Recommendation for revised conditions of approval for a Preliminary Plat on Lots 5 through 15, Block 2, PLM Subdivision:

PLM SUBDIVISION
PLAT OF LOTS 5 THROUGH 15 IN BLOCK 2
LOCATED IN NE1/4NW1/4 OF SECTION 24, T1N, R7E, B.H.M.
RAPID CITY, PENNINGTON COUNTY, SOUTH DAKOTA

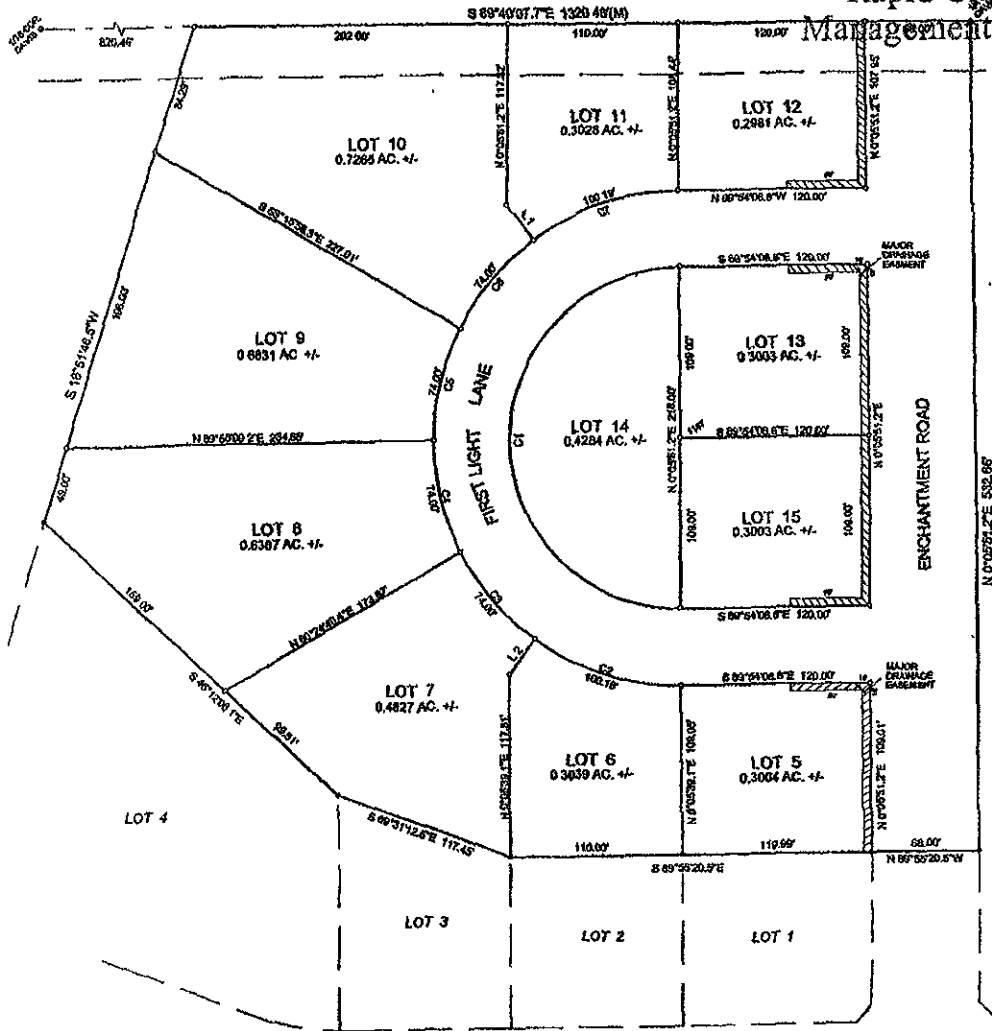
- 4) Prior to Preliminary Plat approval by the City Council, road construction plans for Enchantment Road as it abuts propose Lot 12 shall be submitted for review and approval. In particular, the construction plans shall show Enchantment Road constructed **as a subcollector** with a minimum ~~32~~ **27** foot wide pave surface, curb, gutter, sidewalk, street light conduit, water and sewer **in a 52 foot right-of-way** or a Variance to the Subdivision Regulations shall be obtained or Lot 12 shall be eliminated from the plat document;

- 5) Prior to Preliminary Plat approval by the City Council, a revised grading and drainage plan shall be submitted for review and approval addressing the lots to be developed east of Enchantment Road and north of Enchanted Pines Drive. In addition, the plat document shall be revised to show drainage easements as needed;

- 8) Prior to submittal of a Final Plat application, the plat document shall be revised to show the right-of-way dimension for "First Light Lane";
- 9) Prior to submittal of a Final Plat application, a different street name for "First Light Lane" shall be submitted for review and approval by the Emergency Services Communication Center. In addition, the plat document shall be revised to show the approved street name; and,
